RE: DRAINAGE REPORT FOR CAVAN COMMERCE CENTER
(L-16/D23) RECEIVED OCTOBER 22, 1986

REF REVISED DRAINAGE REPORT FOR YALE BUSINESS PARK (L16-D23)
RECEIVED MAY 27, 1986

Re: Yale Business Park (L16-D23),
Now Entitles Cavan Commerce Centre

SEDIMENTATION POND PLAN

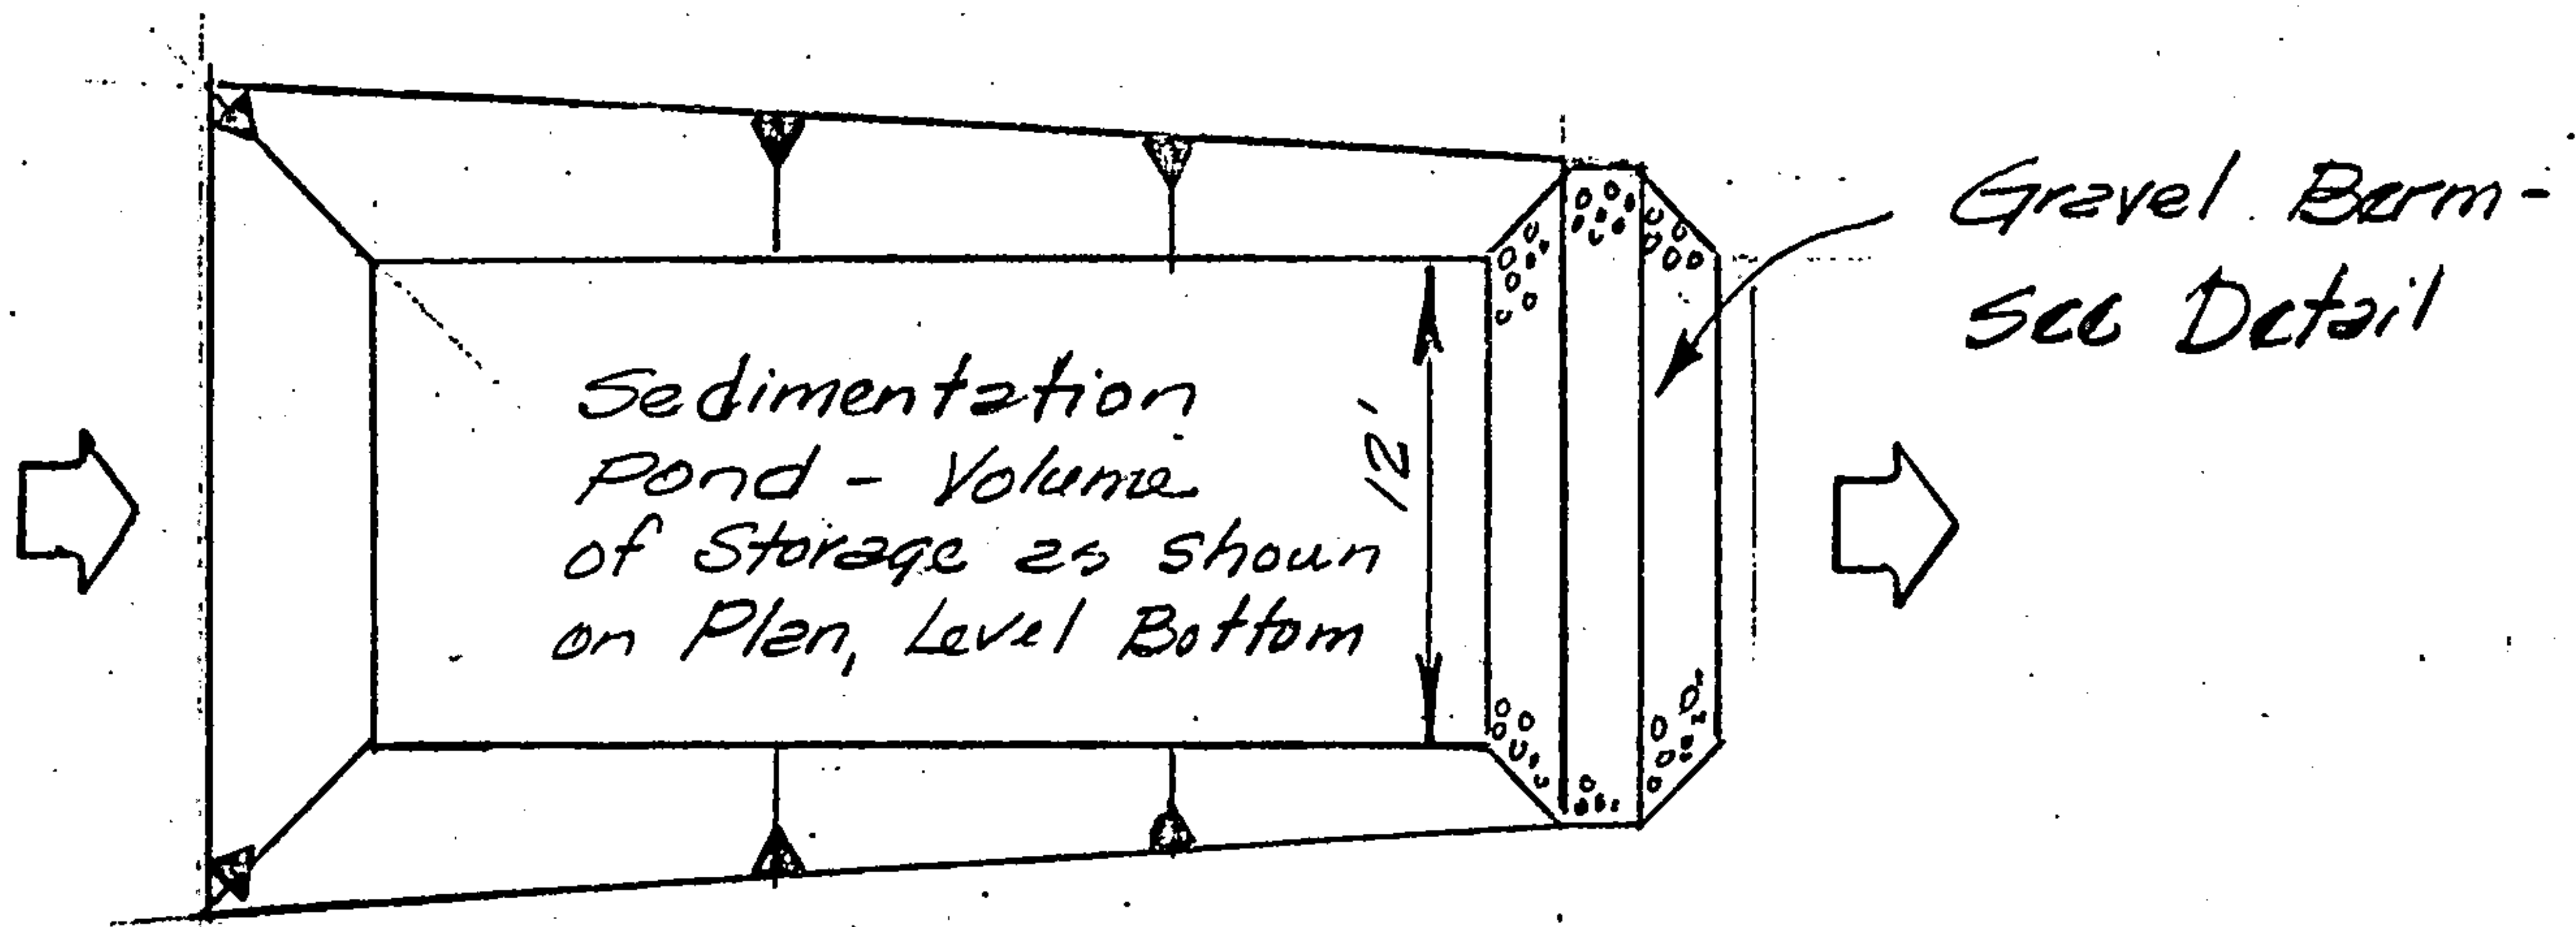
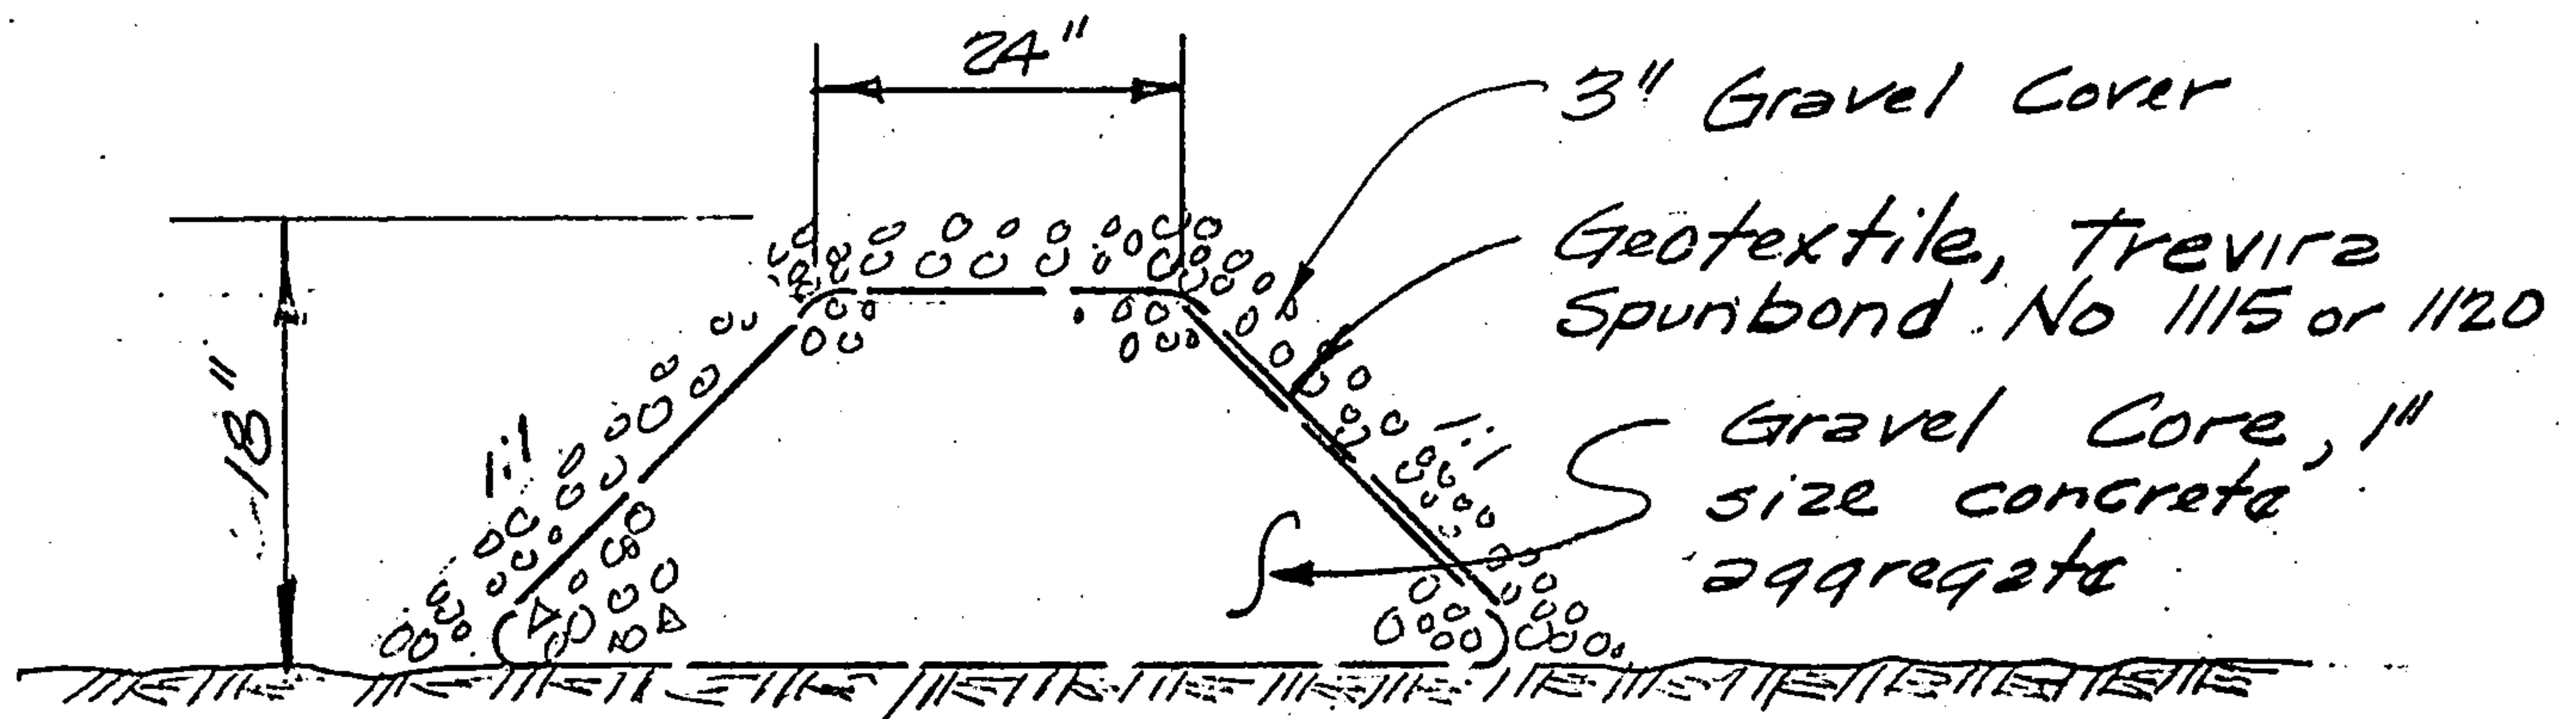
A second revision to the Report is a change to the sedimentation ponding concept. A detailed grading plan has been prepared for the entire subdivision which incorporated sedimentation ponds for each Tract. This grading plan has been approved by Mr. Carlos Montoya and is on file with the Design Hydrology Section. These individual ponds will provide more than the original sedimentation capacity and consequently, the two sedimentation ponds shown on the original Drainage Plan have been deleted.
